ADDENDUM NO. 1 TO BID FORMS

**CORONA-NORCO UNIFIED SCHOOL DISTRICT
PURCHASING DEPARTMENT
Bid No. 2023/24-204**

CORONA FUNDAMENTAL INTERMEDIATE SCHOOL MPR MODERNIZATION

SHEET NO.:
M-601

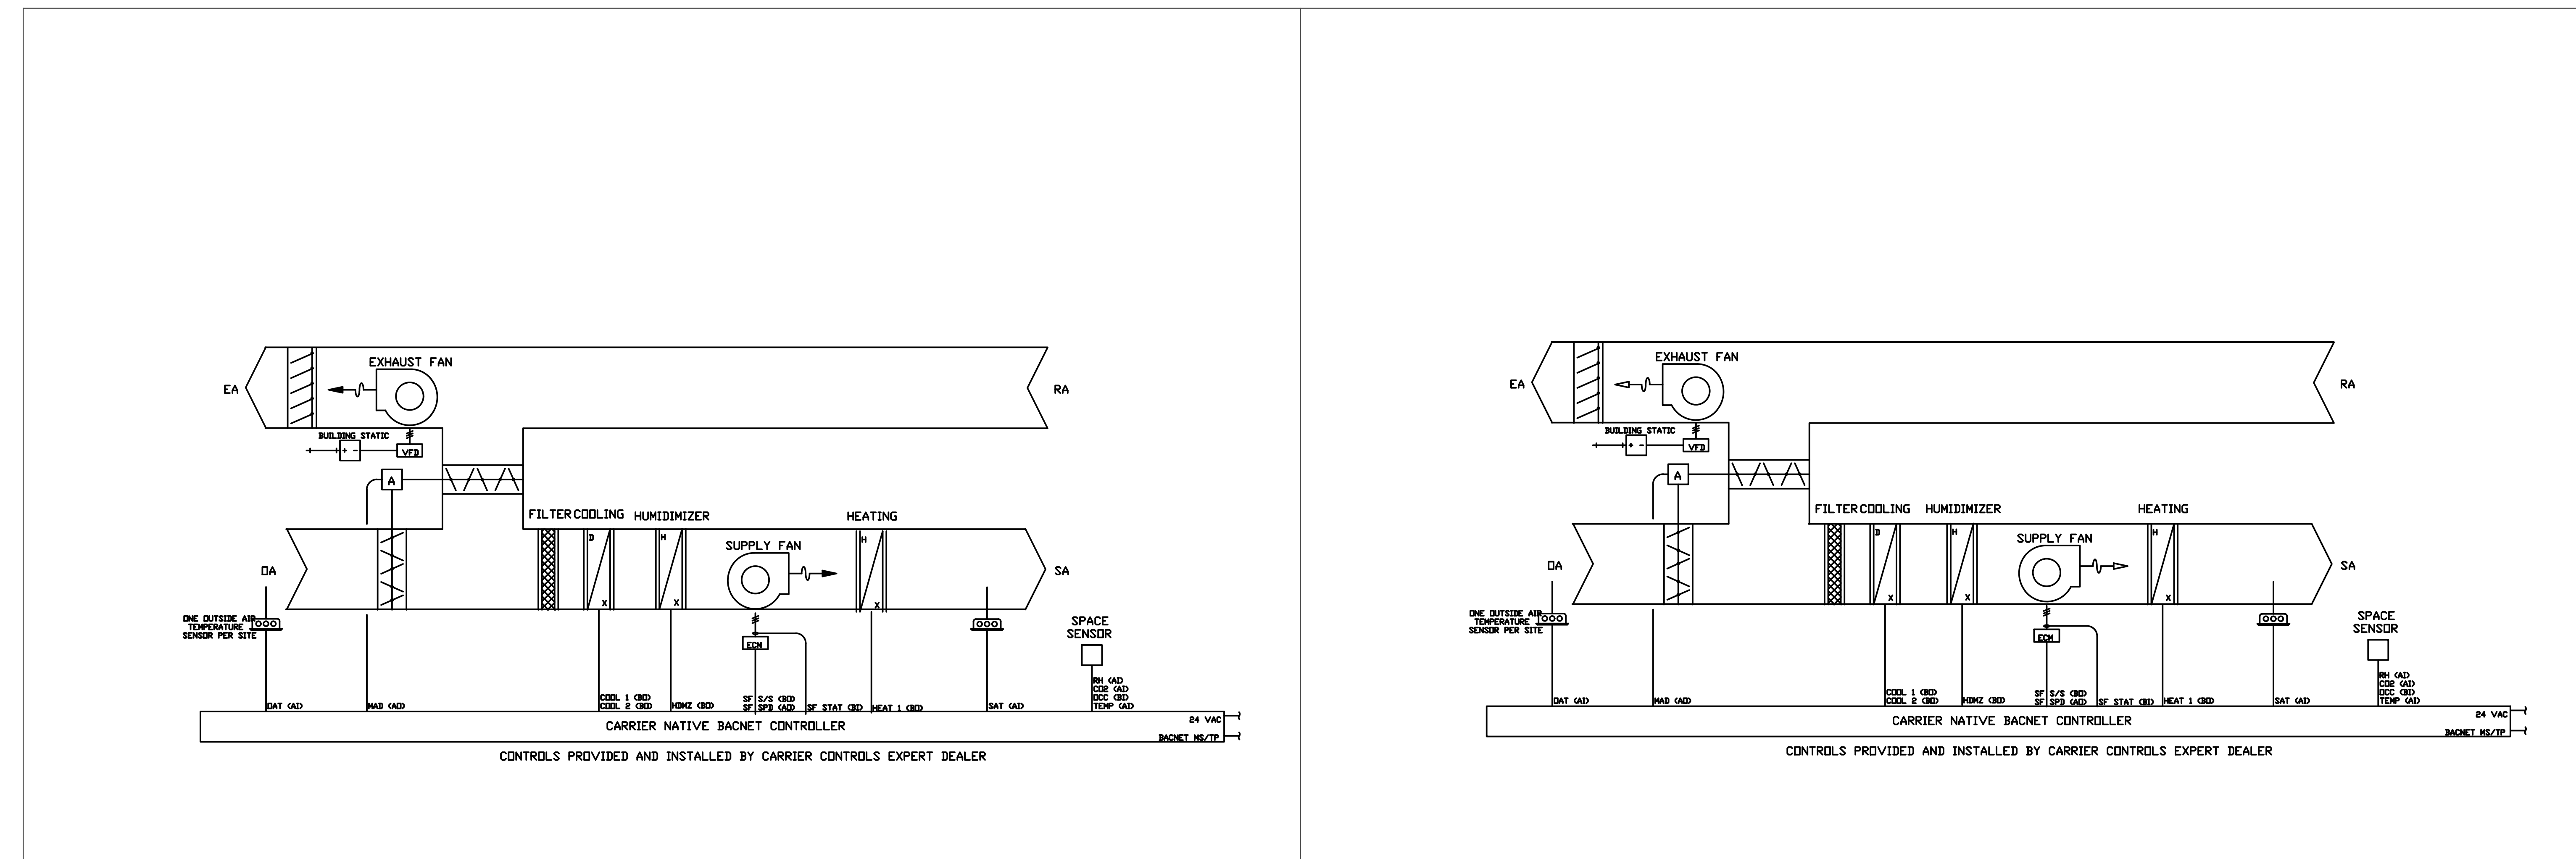
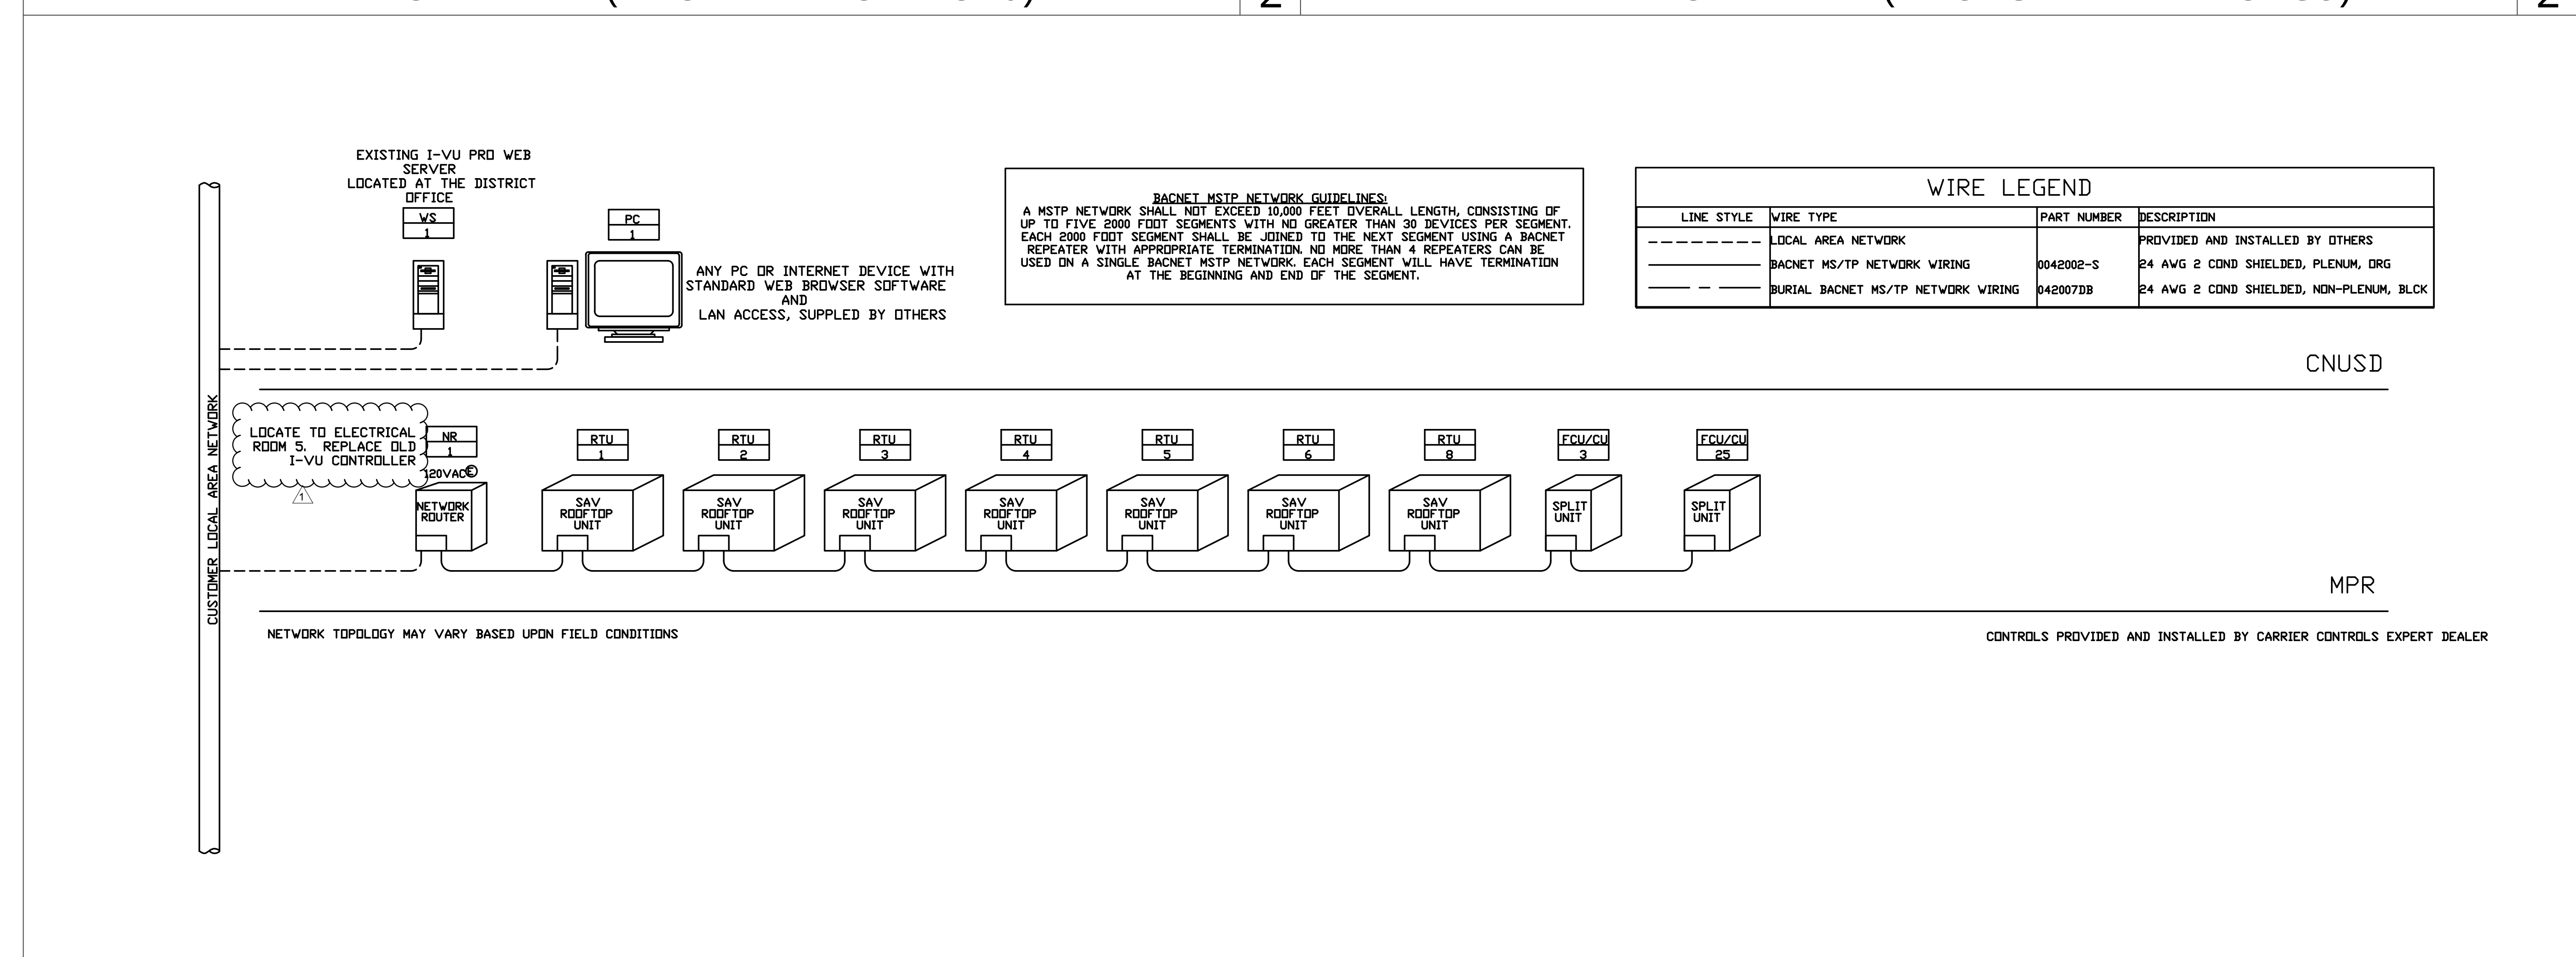
Sheet M-601 – Mechanical Control Diagram

- Add sheet note #A.
- Specify location of new I-VU location.
